# **Final Environmental Impact Statement for the COB Energy Facility**

**DOE/EIS-0343**

**Bonneville Power Administration**

June 2004

**Figure 2-3**  
*Other Potential Sites and Vicinities for Development*  
 COB Energy Facility  
 Bonanza, OR

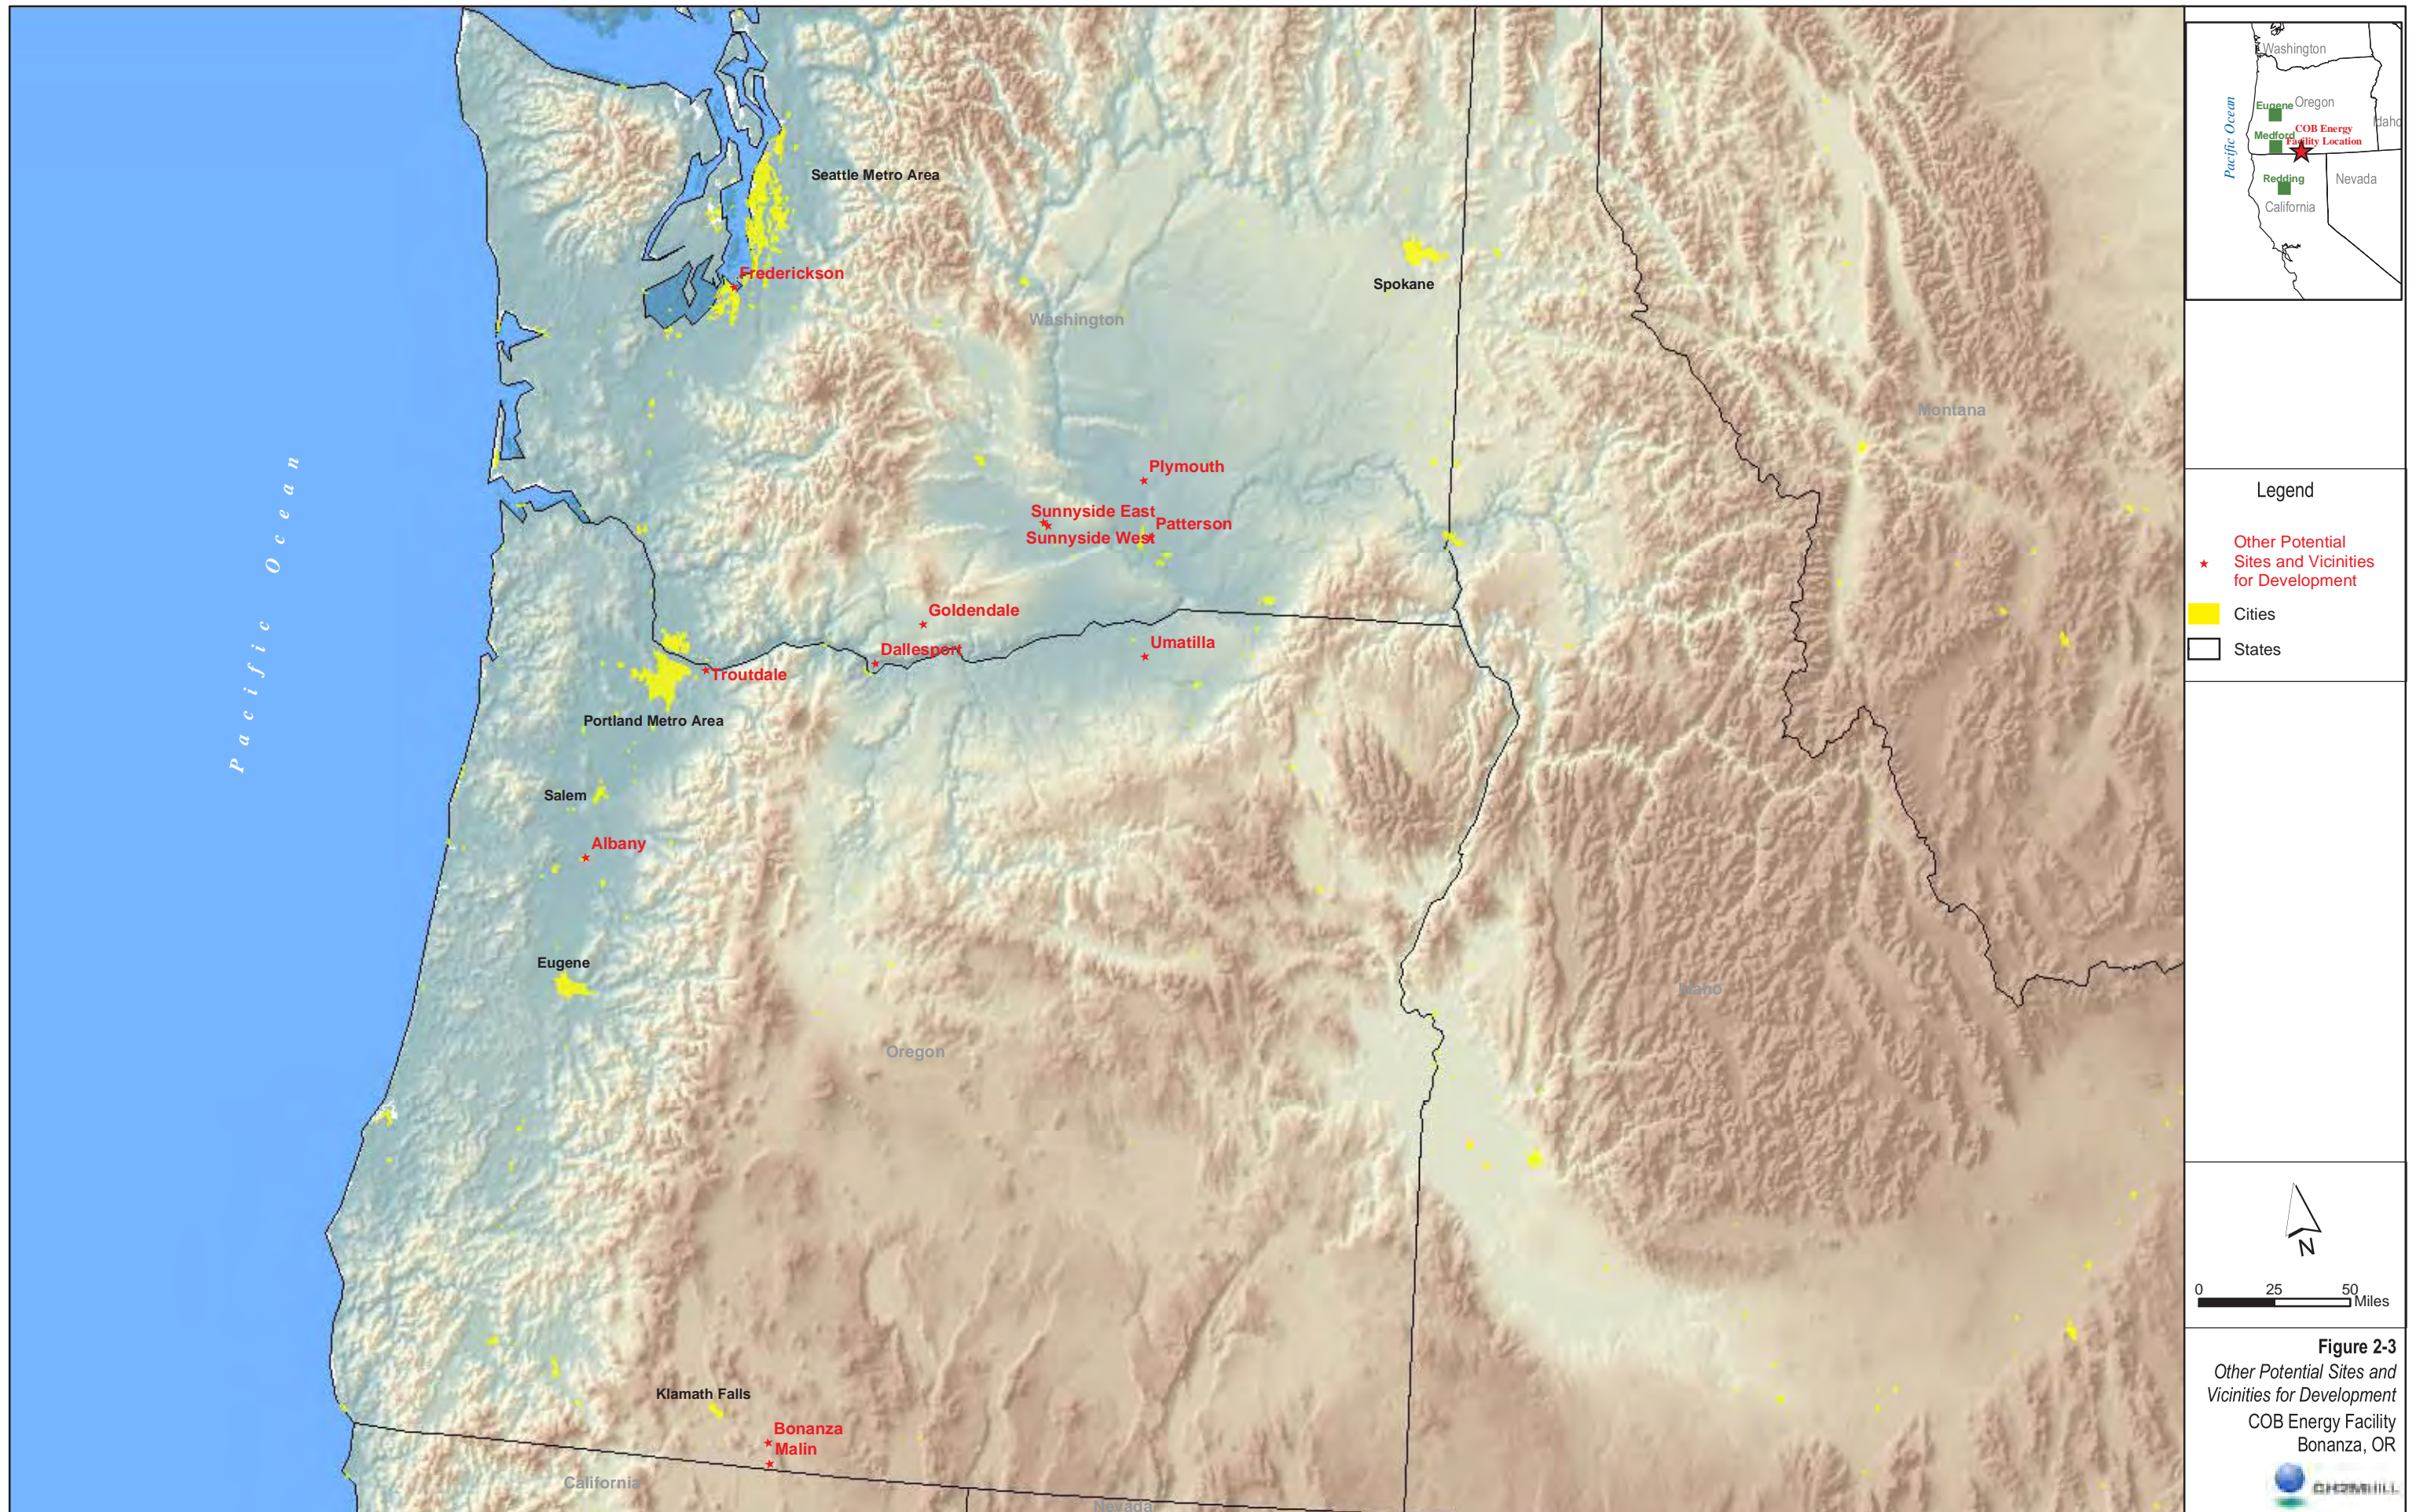
~~Eleven alternative~~ The project proponent identified 11 other potential sites or vicinities in Oregon and Washington (see Figure 2-3 —) were identified by the project proponent as having development potential. None of these ~~alternative~~ sites successfully met the criteria identified above, and none of the sites met the proponent’s fundamental purpose and need for the generation facility.

2.5 Other Alternatives			
2.5.1 Alternative Strategies for Electrical Supply and Demand Management	2-20		<i>No changes</i>
2.5.2 Alternatives Considered but Eliminated From Further Analysis	2-21	3A, 9B, 9C, 15C, 15E, 17C, 17E, 18A, 21B, 23L, 23N, 29B, 29D, 29E, 29F, 29G	<b>Additional text added to the introductory part of this subsection. Figure 2-3, an addition to the FEIS, is cited to illustrate alternative locations considered for potential development. Table 2-2, an addition to the FEIS, cited to show other potential sites and vicinities for development.</b>

**Figure 2-4**  
*Typical Transmission Tower Structure*  
COB Energy Facility  
Bonanza, OR

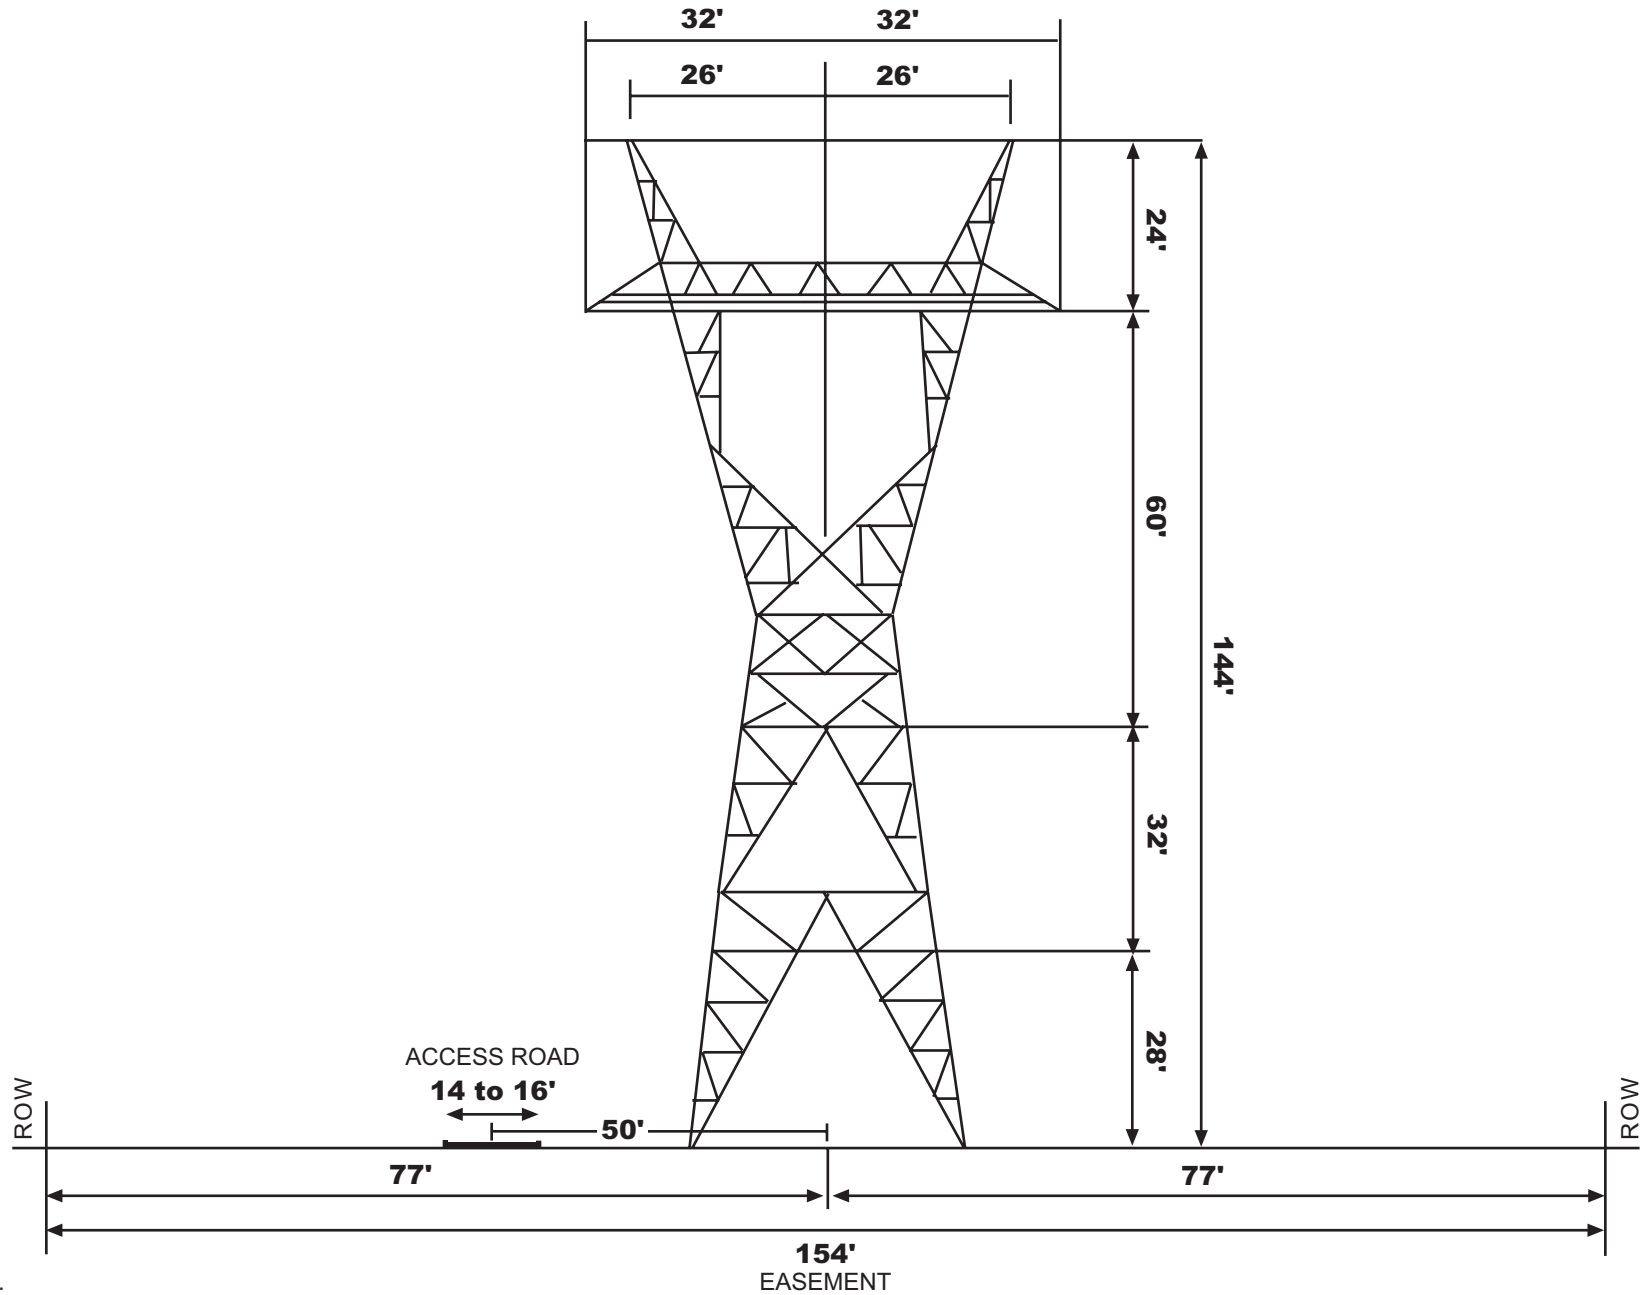
28T1	<p><b>Add, Impact of Proposed Action/Mitigation, 3.1.3:</b> <u>The proposed project facilities and transmission towers may impact scenic views for recreational users in the vicinity of the project but would not affect recreational public or private facilities.</u></p>
<b>Chapter 2 Figures</b>			<p><b>Revised Figure 2-2.</b> <u>Figure 2-2 will be revised to show BLM-managed land. Figures 2-3 and 2-6 will be added. Figures 2-4 and 2-5 will be renumbered. See Part 3 New and Revised Figures.</u></p>

**Figure 2-5**  
*Typical Water Supply Pipeline Configuration*  
Biological Assessment  
COB Energy Facility  
Bonanza, OR

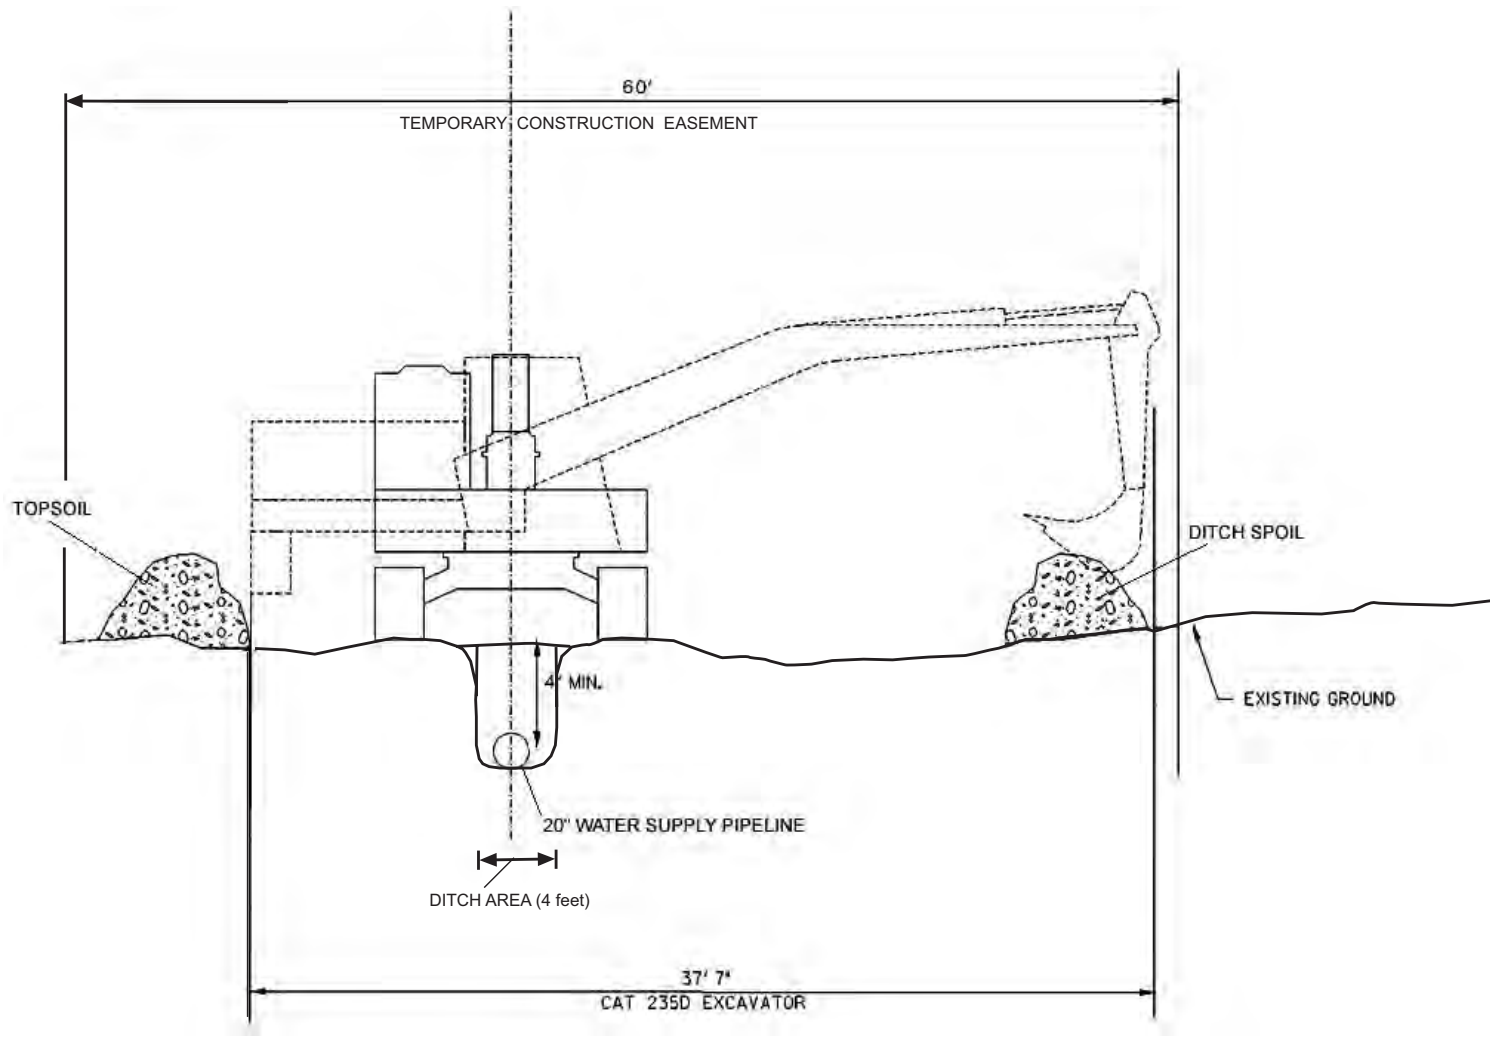
The water supply pipeline would be installed in a 36-inch-wide trench at a depth of about 4 feet. The trench would be backfilled with pipe zone material and then with native soil up to the original grade. Figure 2-54 shows a typical section of the water supply pipelines.
